STAMP SHELDON E. GREER NEW MEXICO LICENSED PROFESSIONAL ENGINEER 01/22/2024									
THIS DRAWING IS INCOMPLETE AND NOT TO BE USED FOR CONSTRUCTION UNLESS IT IS STAMPED, SIGNED AND DATED.									
PROJECT NAME: TIDAL WAVE 2ND MENAUL									
SHEET TITLE: UTILITY PLAN									
SUBMITTED FOR: BUILDING PERMIT									
SHEET NUMBER: C-107

COMMENT RESPONSE LETTER

To: Albuquerque Water Utility Authority
From: RESPEC
Date: June 14, 2024
RE: Application For: SI-2024-00547 – EPC site plan sign-off

UTILITY PLAN COMMENT RESPONSES

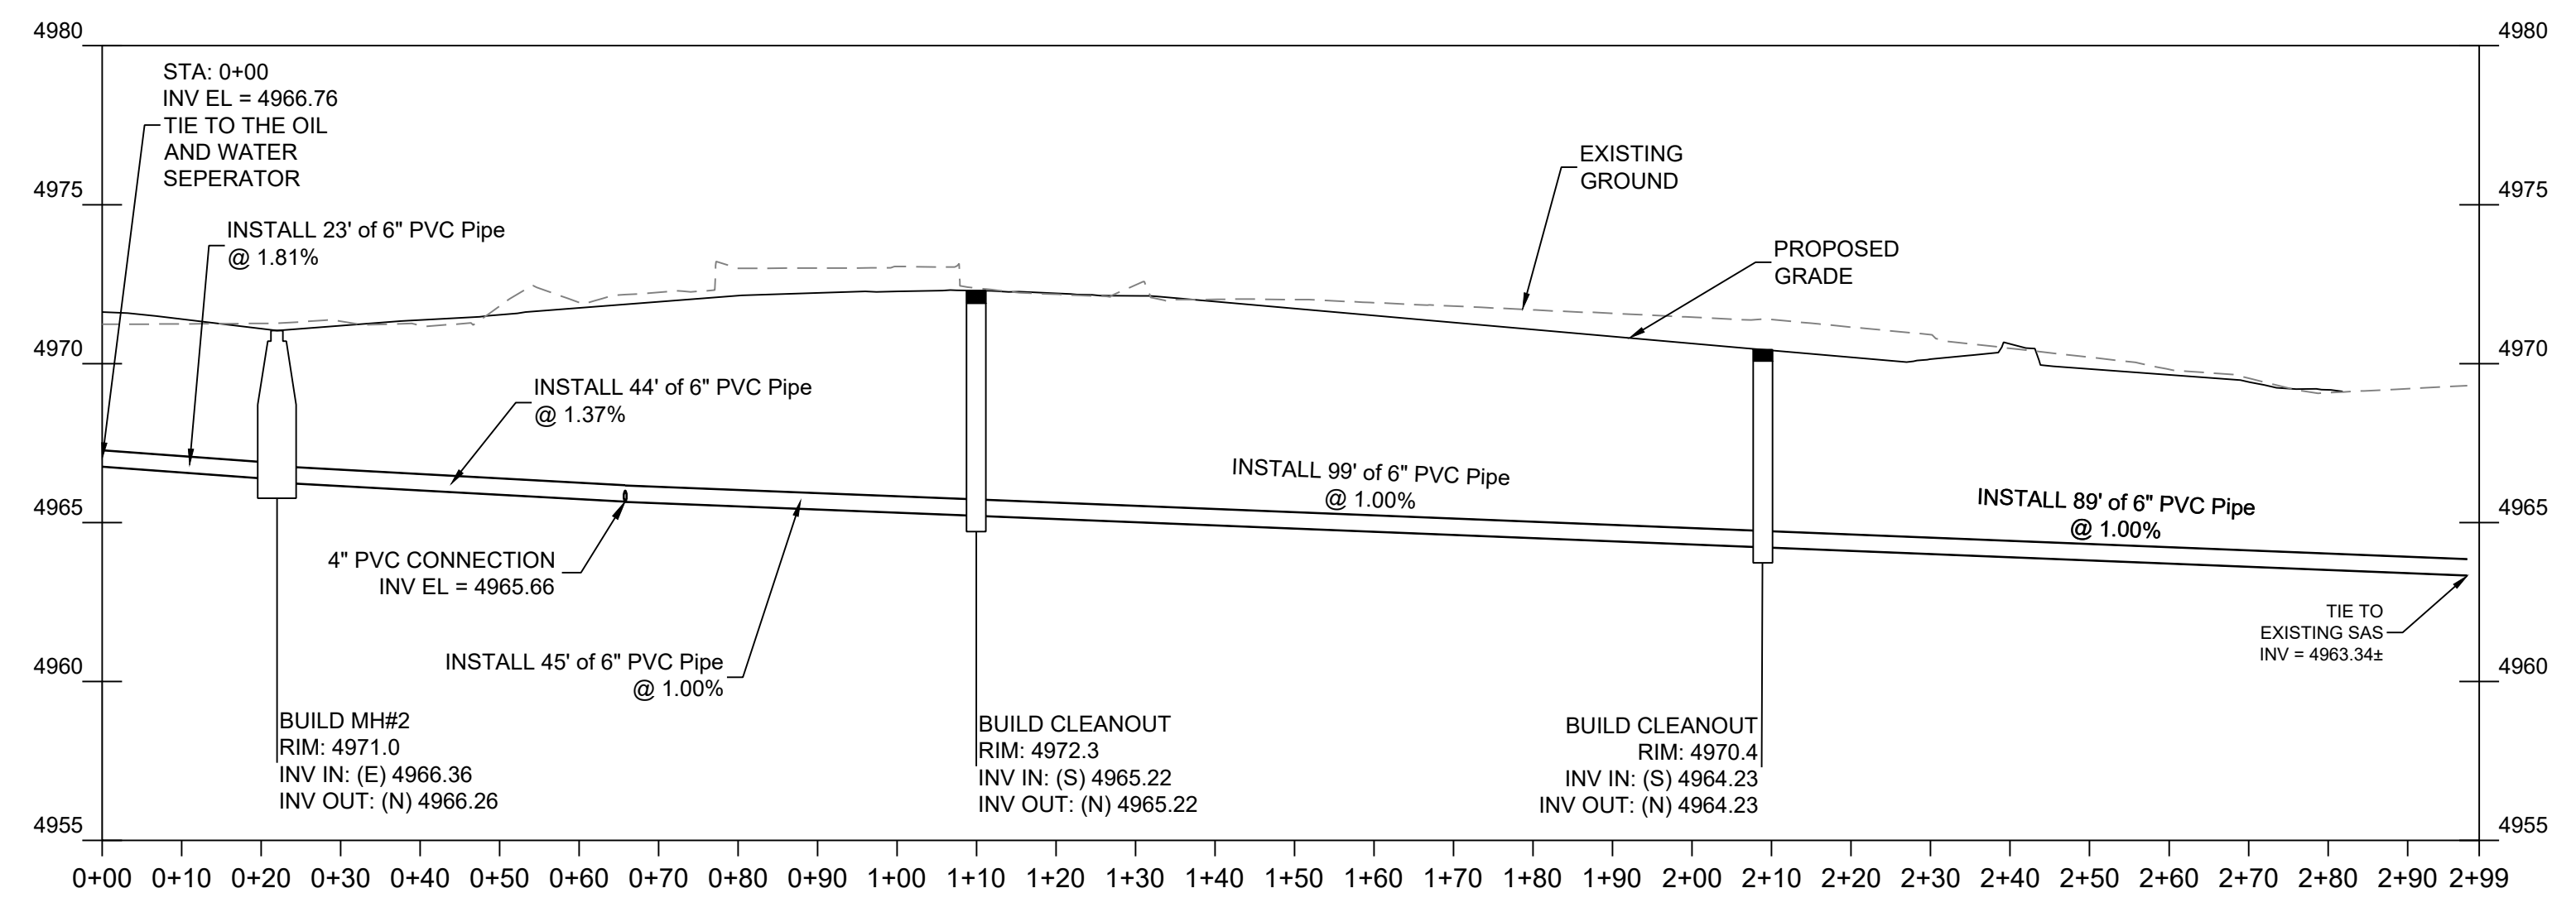
- a. Please add the following notes to the Master Utility Plan. Additionally, please coordinate ahead of time with the
- i. Coordination with Water Authority Cross Connection Section will be required to ensure proper backflow containment is in place prior to release of meter for the site. Contact the Cross Connection Section at 505-289-3454.
 - ii. Coordination with the Water Authority Pre-Treatment Engineer is required to ensure the site complies with Water Authority Sewer Use Ordinance. Contact the Pre-Treatment Engineer at 505-289-3439.

- b. Please appropriately label infrastructure as public or private.
[A note has been added to the utility plan that addresses this.](#)

c. Please figure out if the existing meter is adequate size or not to avoid ambiguity. If needed, please contact our customer service to get someone to meet you out there to determine the size.

- i. Currently the bill size is a size 2 which indicates it is sized for a 1" meter.
- ii. There is also an account showing a size 1 which is a ¾ inch meter.
- iii. Please research and determine what will happen with these existing services. Any that are unused will need to be abandoned (shutoff and removed to the corporation stop).

[These notes have been added to the utility plan.](#)

[The existing 1 inch meter located to the north of the site will be removed and replaced with a 1½ inch meter. The existing ¾ inch meter located to the northeast of the site will be reused as an irrigation meter.](#)
